Municipal Class Environmental Assessment Study: Credit River Erosion Control Project from Dundas St West to Highway 403

Credit River Erosion Control EA & Detailed Design
Dundas Street West to Highway 403

SITE #1 – POTENTIAL PREFERRED ALTERNATIVE

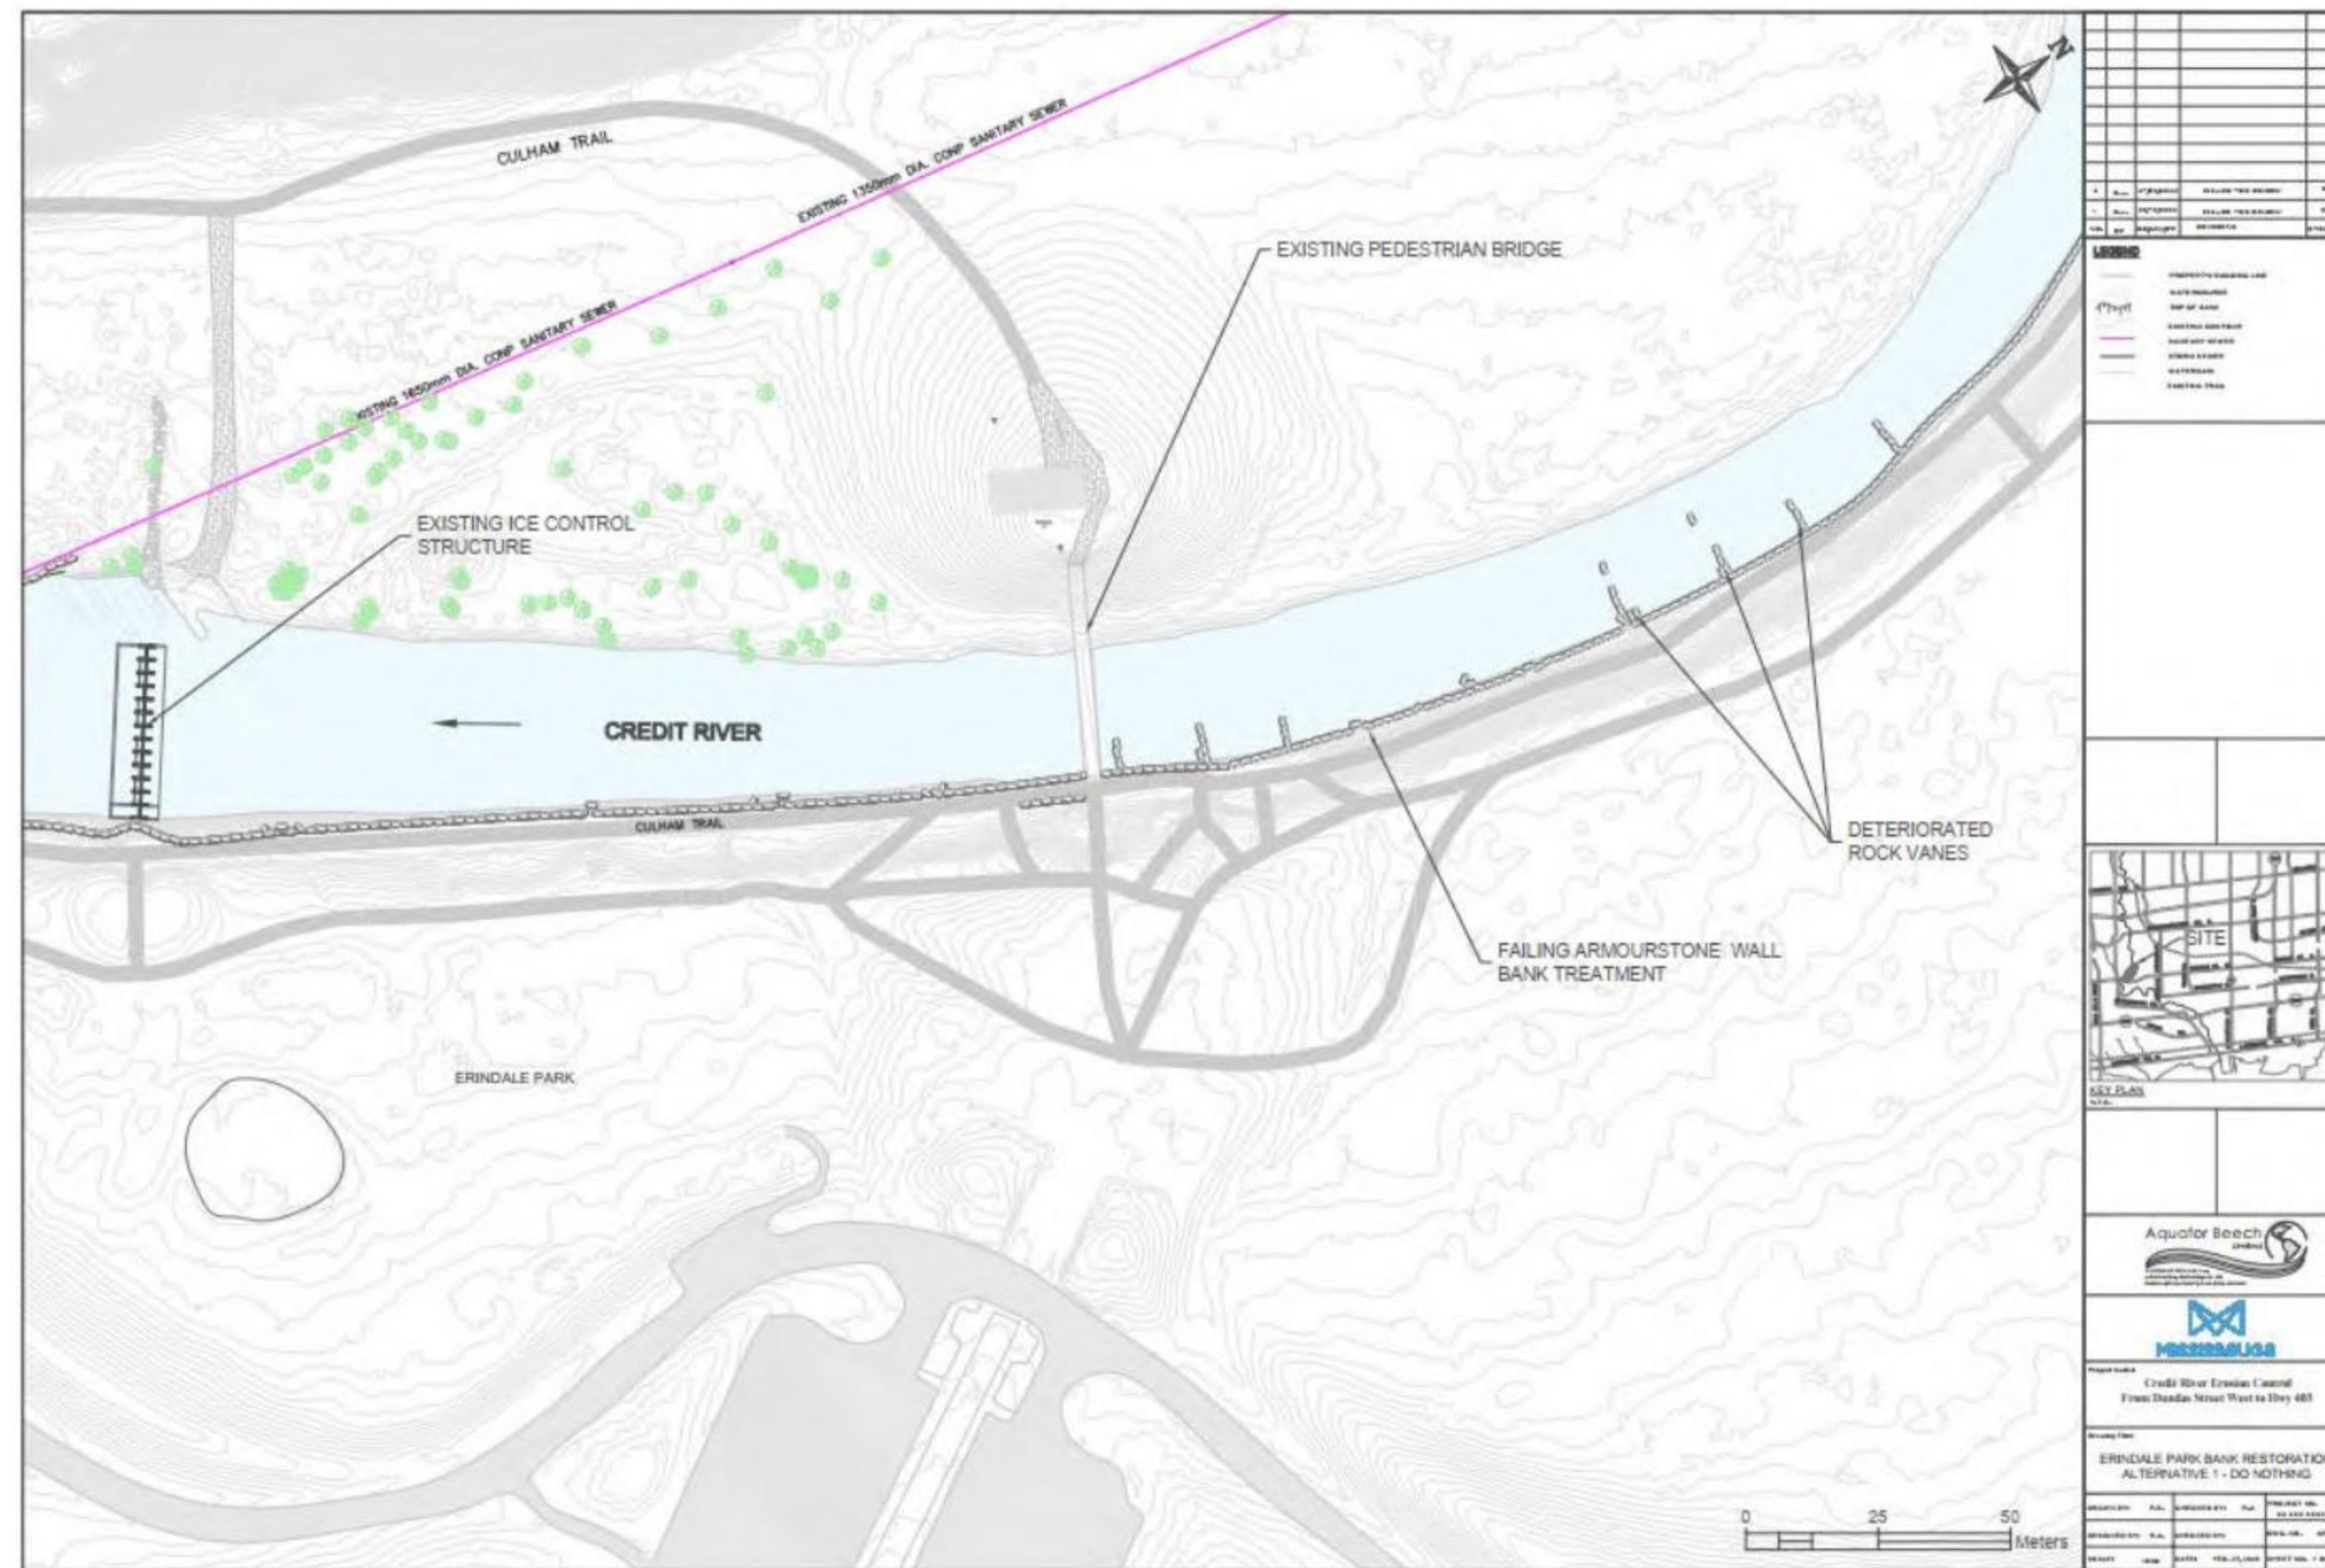
4.	<p>For Drawing 1 – Ice Control Structure, Alternative 3 has been chosen which shows vegetation removals within a mapped woodland and areas planted by City contractors. In addition to the information still needed (outlined in the comments above), please indicate:</p> <ul style="list-style-type: none"> a. If alternative designs have been explored that preserves more of the mapped woodland and justification for the proposed woodland impacts and soil disturbance; b. If wildlife habitat, including SAR bat roosting trees, are present within the woodland; and 	<p>The plantings to the south of the control structure were not intended in the original design of the structure. The select removal or thinning of trees in the floodplain recommended in the preferred alternative (Alternative 3) has also been proposed by CVC since 2016. The select removal of trees is intended to increase ice storage area in the floodplain and restore a key original design element of the ICS, as trees lining the riverbank tend to contain the ice within the channel (USACE Ice Engineering, Tuthill and Lever, 2006). The environmental benefit of mature trees in the riparian area will be carefully considered in future design stages of this project when a detailed tree removal, management, and compensation plan will be</p>

SITE #2 – POTENTIAL PREFERRED ALTERNATIVE

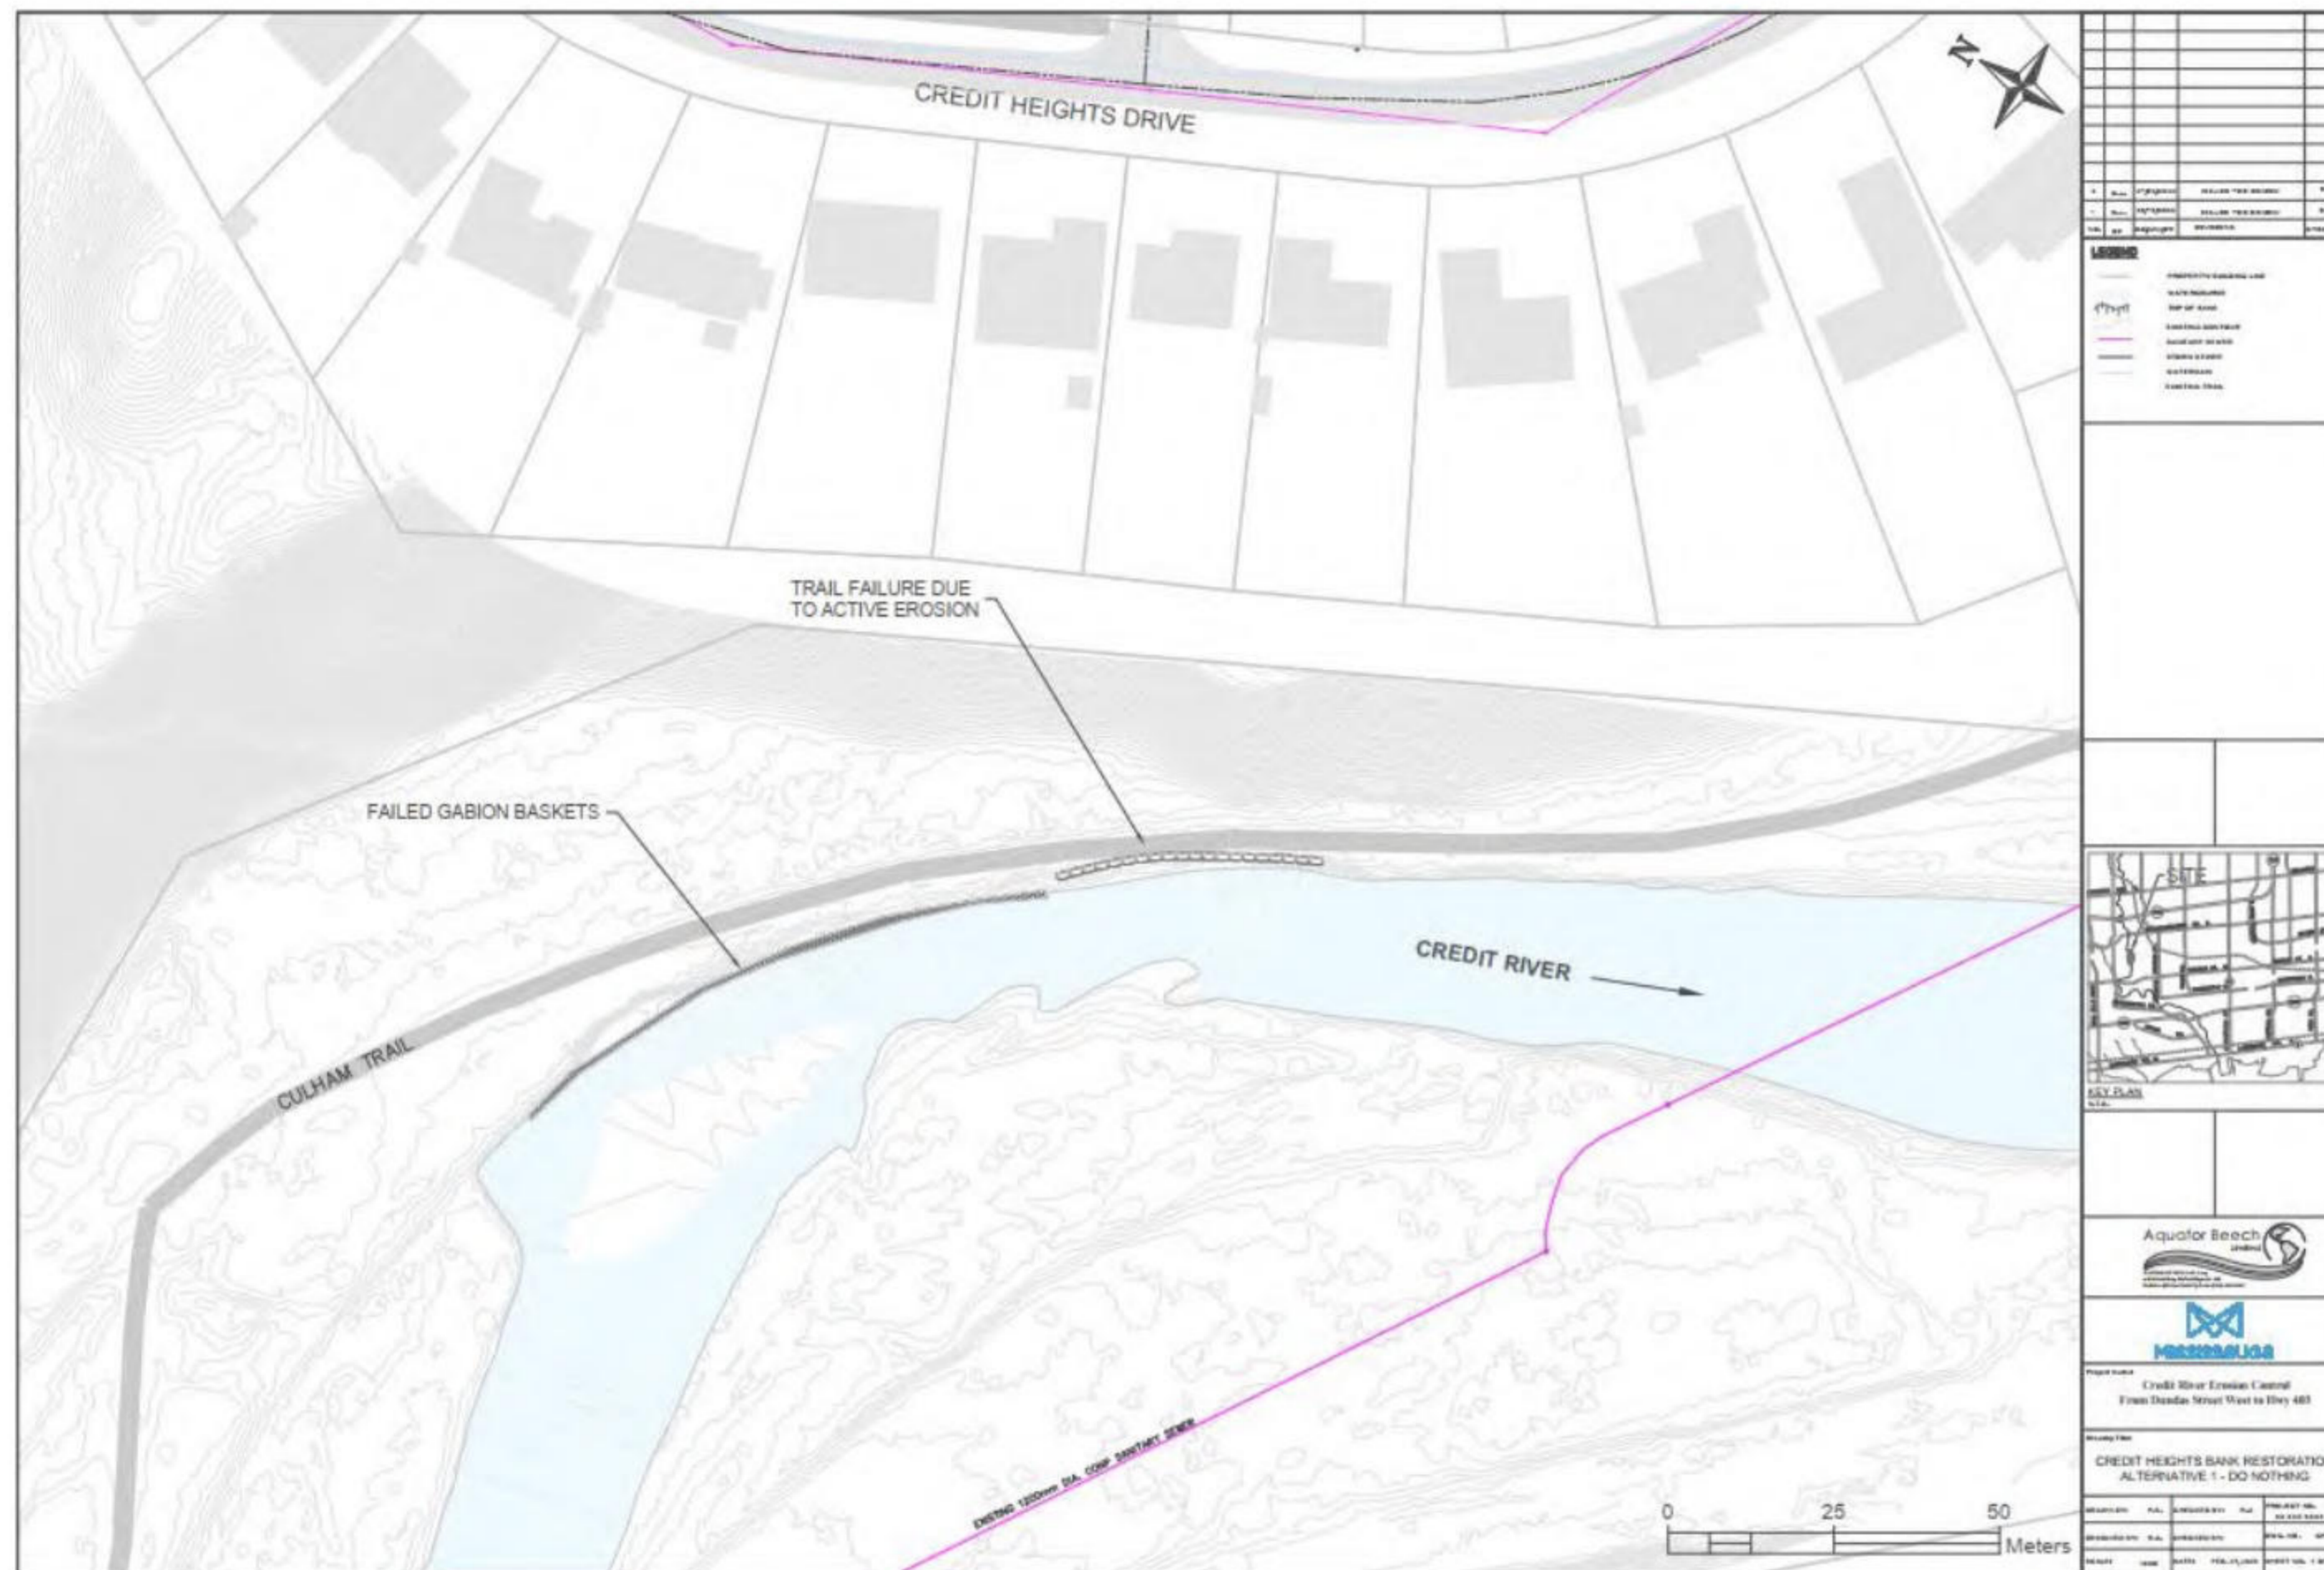
5.	<p>For Drawing 2 – Erindale Park Bank Restoration:</p> <p>a. Remove the proposed 1.2 m informal trail to maximize naturalization, especially since the bank will receive more hardening. That proposed informal trail should be densely planted with native trees and shrubs to increase bank stabilization and reduce fragmentation of riparian vegetation communities. There will be enough paved paths in the park to allow visitors access to the river and existing trail network. Reducing informal trails helps to concentrate visitor associated impacts in more appropriate areas and discourage vegetation trampling along the rivers banks. It also reduces confusion for visitors between formal/official trails and unofficial ones; and</p> <p>b. Proposed naturalization plantings will need to be very dense to both stabilize the bank, reduce surface water runoff into the river, and to act as a visual and physical barrier to visitors going off trail. Shrubs should be at least 75 cm tall and planted at a minimum density of 10,000 shrubs per hectare. Tree plantings of 1-3 gallon stock that is a minimum 1.5 m tall is also encouraged, which would be at a density of 1,200 trees per hectare.</p>	<p>The informal path notation was replaced with "decommission existing natural surface trail and regrade 1.2m naturalized buffer". The recommended density of plantings has been noted.</p>
